PLP Classroom & Change Room Alterations at Dunbarton High School

Tender # T24-22

ADDENDUM NO. 1

Issued by email May 2, 2024

TYPE 4
H.M. INT

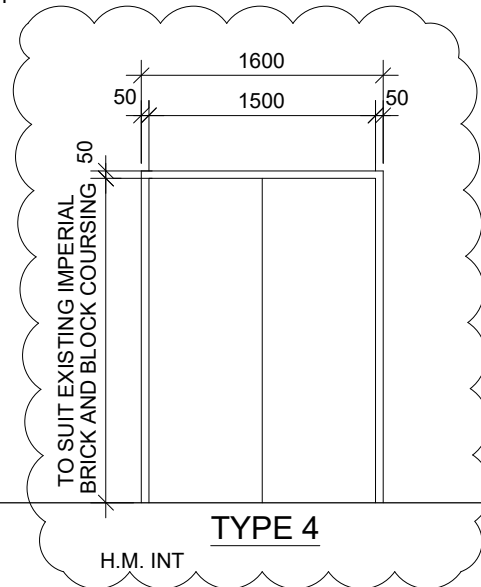
Re: Door Schedule - Door 4416A/B is shown to have a type 3 frame but is only a pair of doors, not a screen which type 3 is. Please advise.

A: Door 4416A/B is a double door into the Storage Closet. A new type 4 frame has been added to AD801 to differentiate this frame from the other Type 3 & 3A double door frames which have adjacent screens.

- .1 Door 4416A/B - CHANGE Door Frame Type from 3 to 4.

- .1 REPLACE with new revised AD801 attached.

11 BUILDING SECTION - CHANGE ROOM
A6.2 SCALE: 1:100

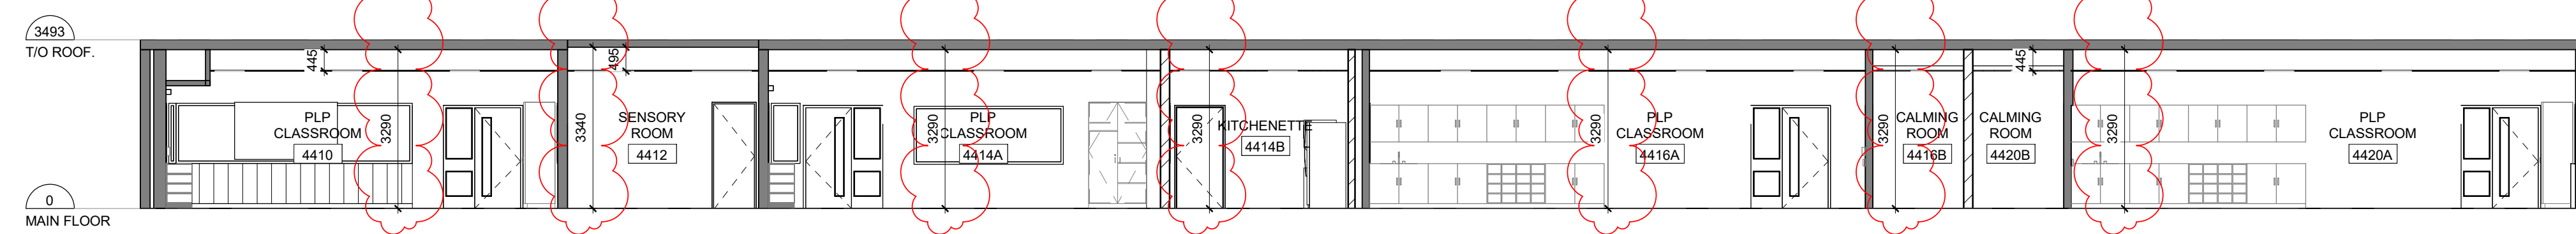
What is the height from finished floor to underside of the metal deck above at each renovation area?

A: **Renovation Part 1: Change Room**

The height from the Finished Floor to the underside of concrete floor slab in the change room renovation area is approx. 3,465mm.

Renovation Part 2: PLP Classroom

The height from the Finished Floor to the underside of concrete roof slab is approx.. 3,290mm in the PLP classroom (4410, 4414A, 4416A & 4420A), Kitchenette 4414B, Calming Room (4416B & 4420B) and Sensory Room 4412.

Refer to Building Section – Change Room (11/A6.2) and Building Section – PLP Classes (12/A6.2)
